RE: Olympic Chemical: Rule Exemption Request, WAC-480-60-50

Attachment "A" Proposed Security Fence

Proposed Sulfur Dioxide Security Fence

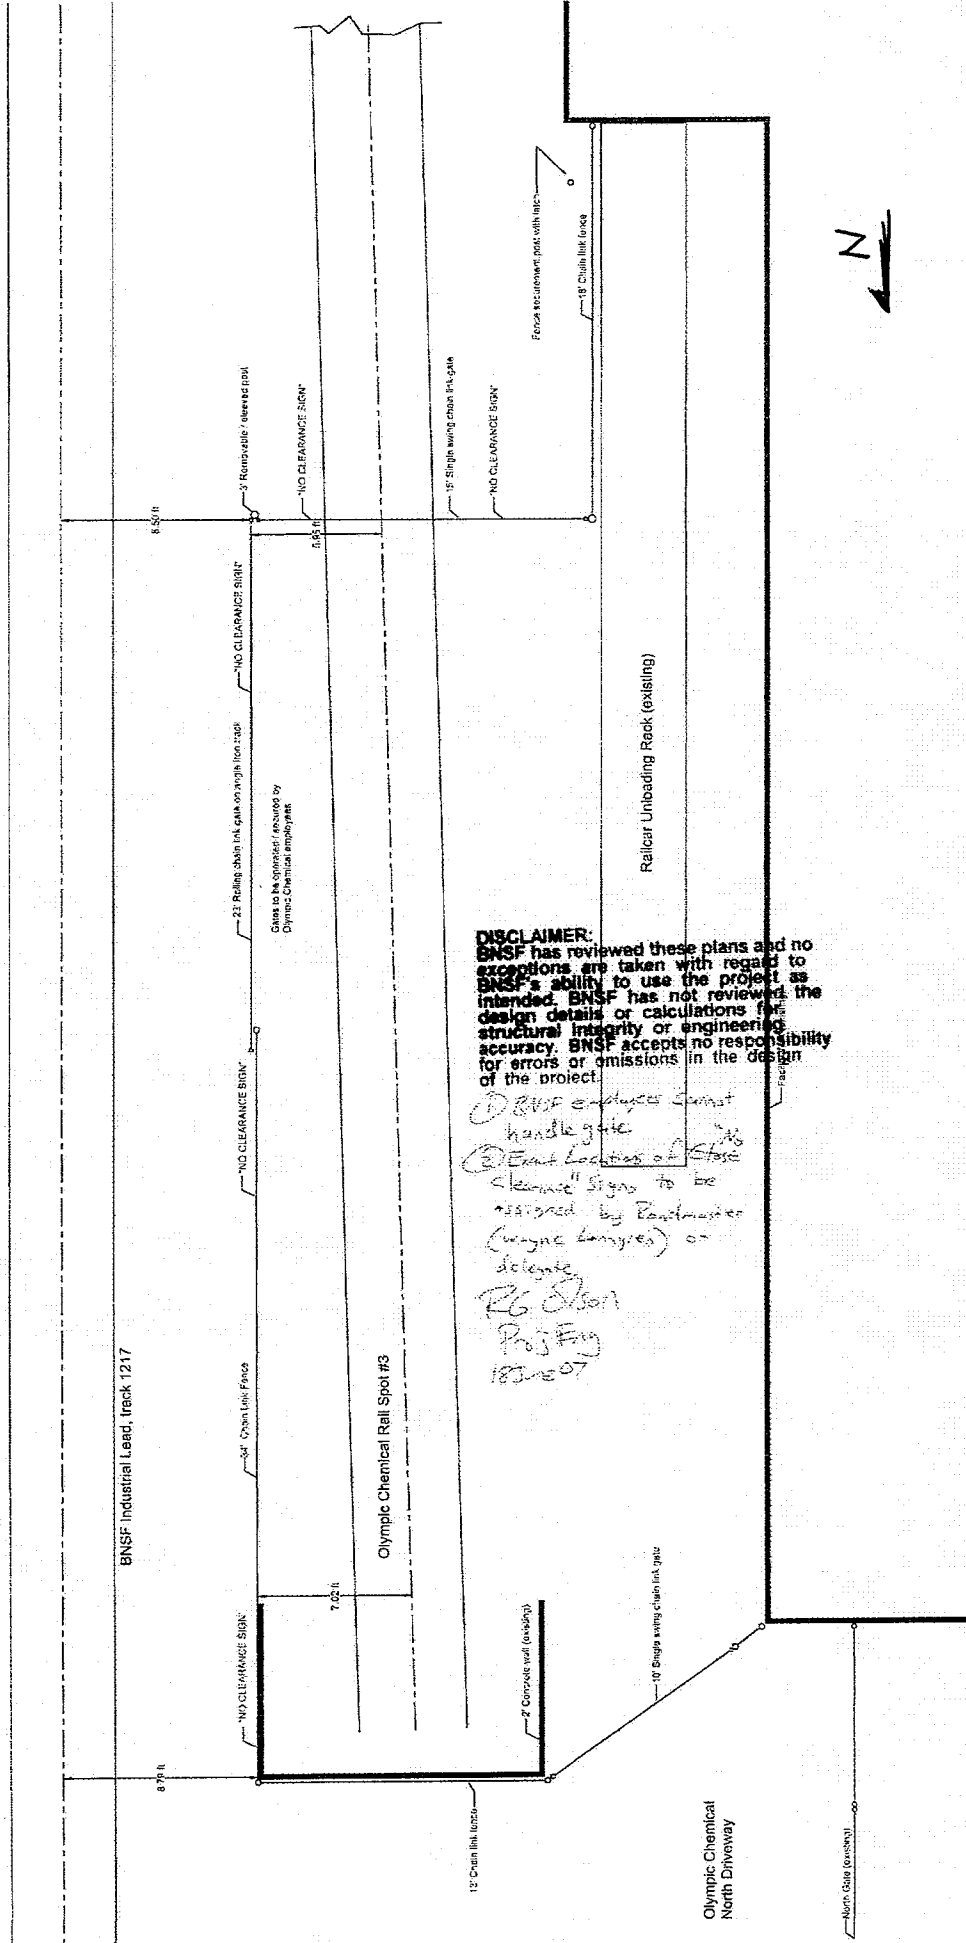
DISCLAIMER:
 BNSF has reviewed these plans and no exceptions are taken with regard to BNSF's ability to use the project as intended. BNSF has not reviewed the design details or calculations for structural integrity or engineering accuracy. BNSF accepts no responsibility for errors or omissions in the design of the project.

① BNSF employee must handle gate
 ② Exact location of these clearance signs to be assigned by Railmaster (Wayne Langley) or detainer
 RG Olson
 Proj Eng
 18JUN07
